### **ADDENDUM 1**

SUBJECT: SAPD Academy Track Pavement, (ID No.: 23-04058), Date of Issue: Friday, August 1,

# THIS NOTICE SHALL SERVE AS ADDENDUM NO. 1 – TO THE ABOVE REFERENCED INVITATION FOR BIDS

Project: SAPD Academy Track Pavement

**CROSS SECTIONS**

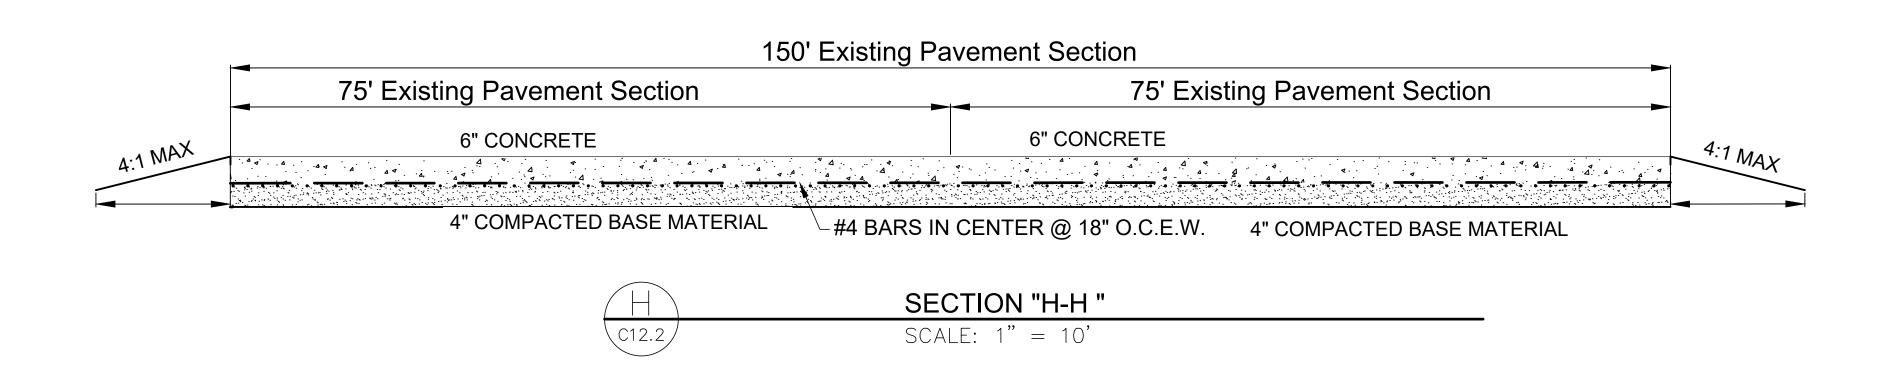
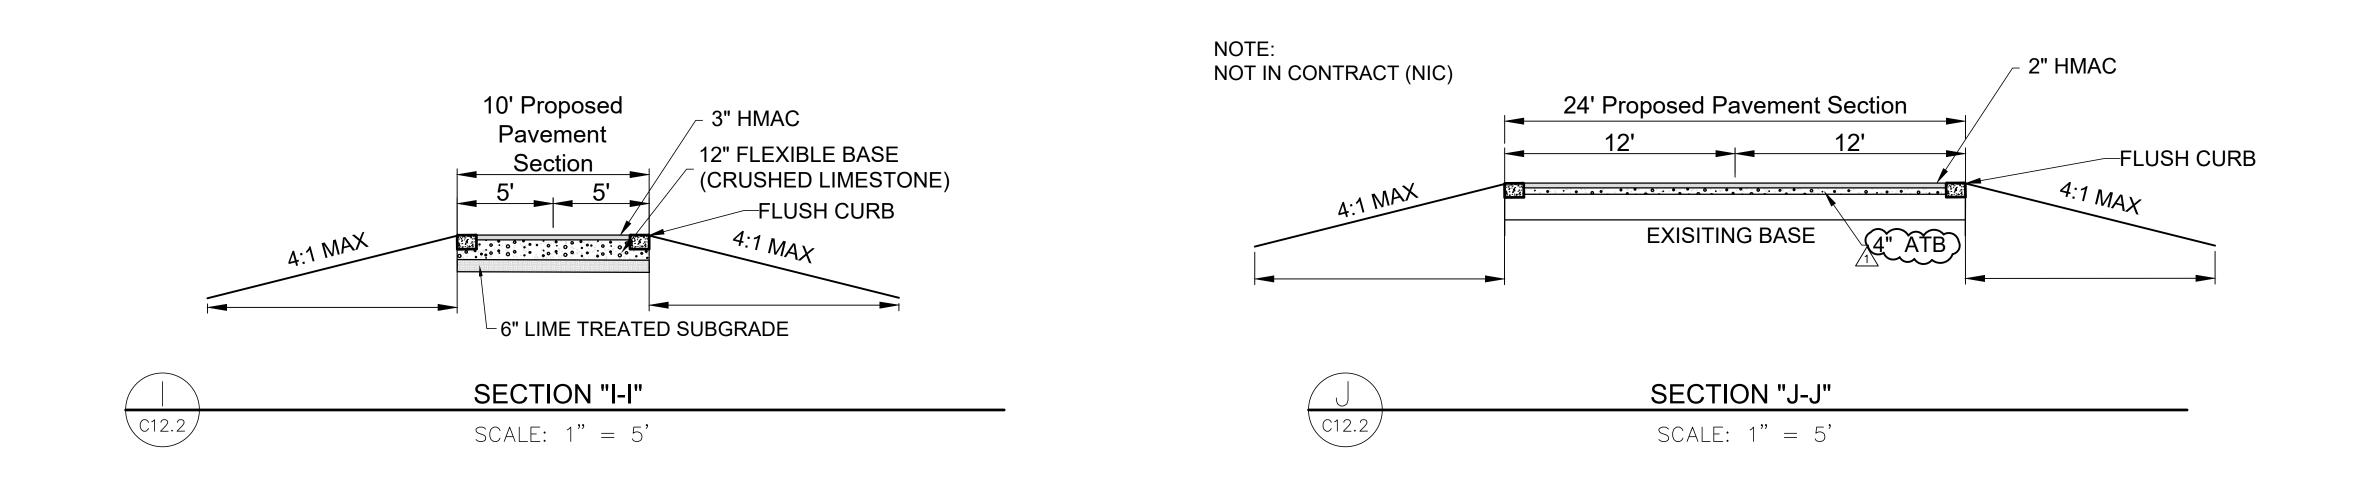
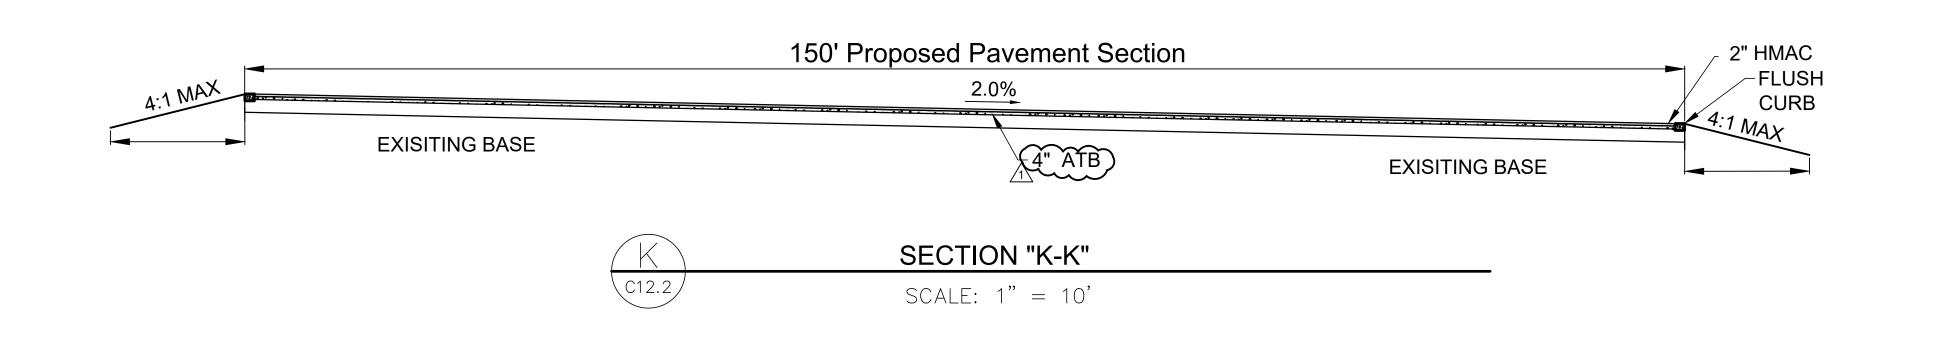
Question 9: In reviewing the various paving sections on Sheets C12.0 - C12.2, can you provide the required distance items like 6" Lime Treated Subgrade, 8" CTB and 12" Flex Base

Use the flush curb as the tie-in/termination for the pavement section. The 6" limetreated subgrade, 4" ATB and 12" Flex Base do not extend past the curb at the shoulders - each layer stops at the back of curb.

# **PAVEMENT DETAILS**

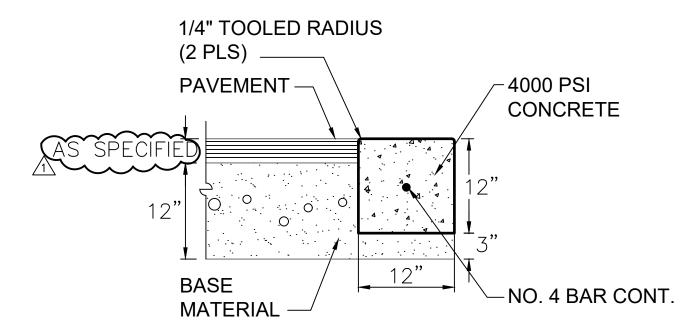
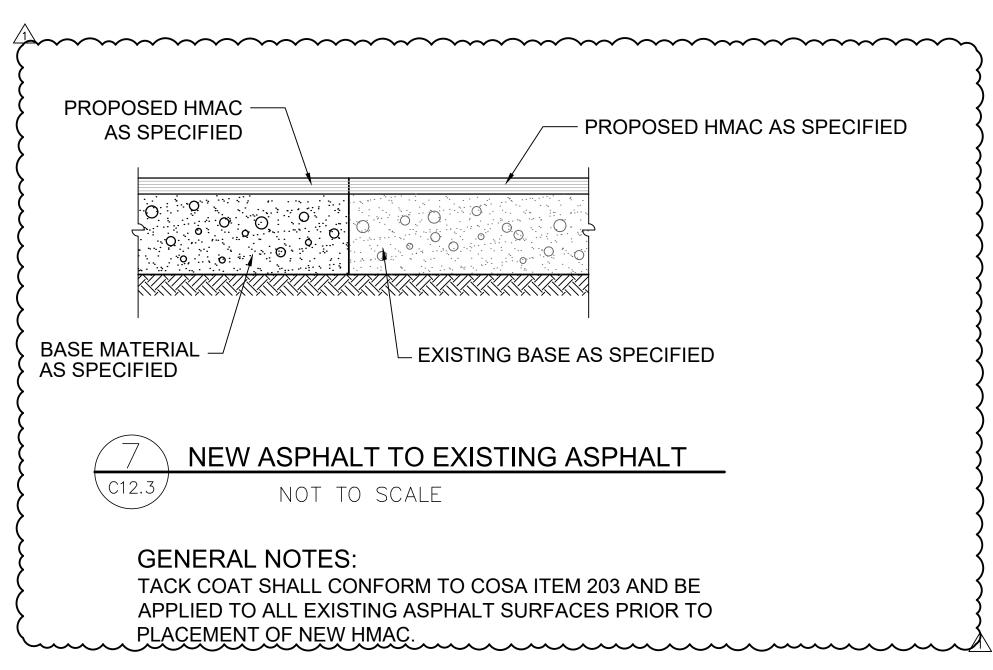
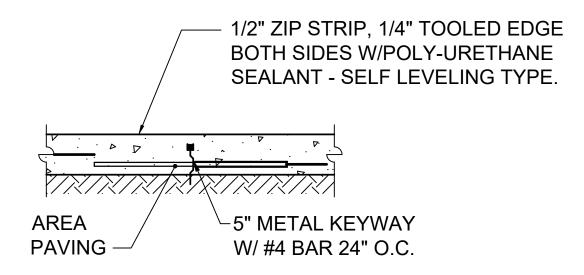
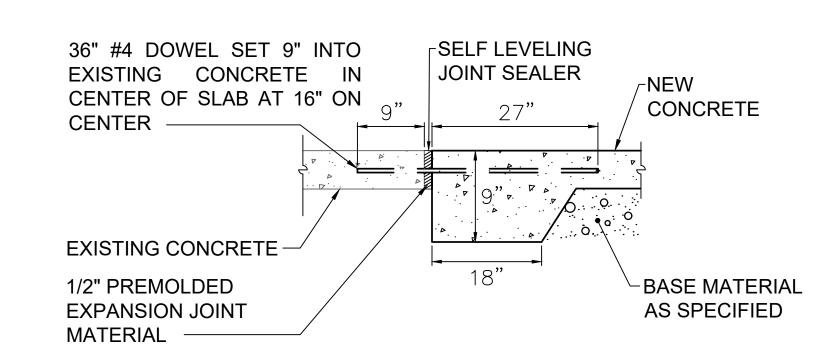
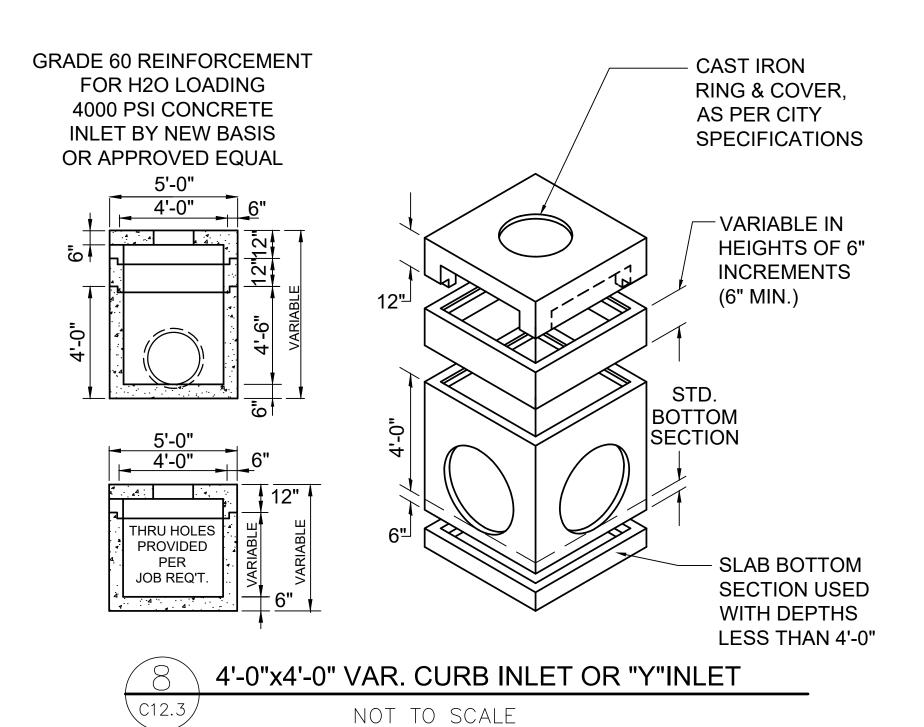
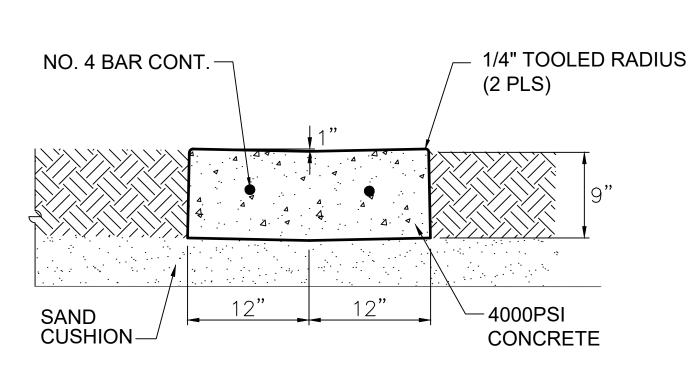
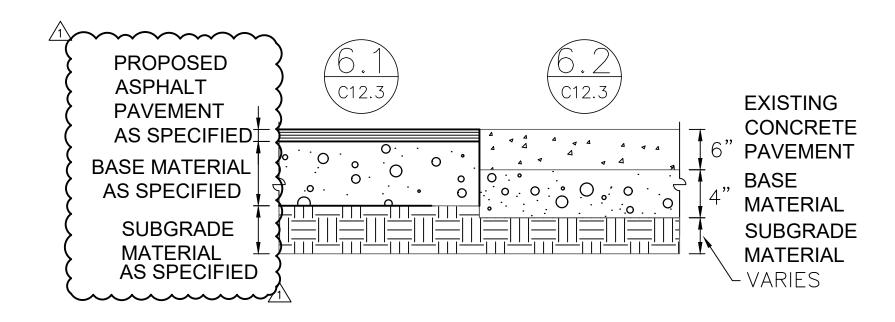
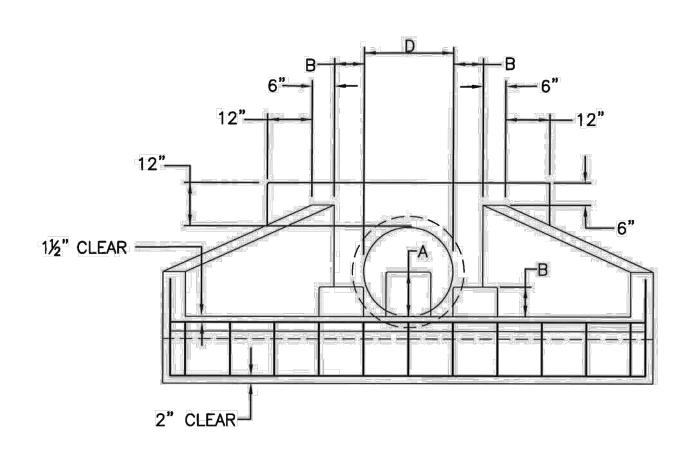
Question 19: What will be the required method for tying the new pavement into the existing pavement, and can you please provide the construction detail for this tie-in?

Response: Yes, please see details on sheet C12.3.
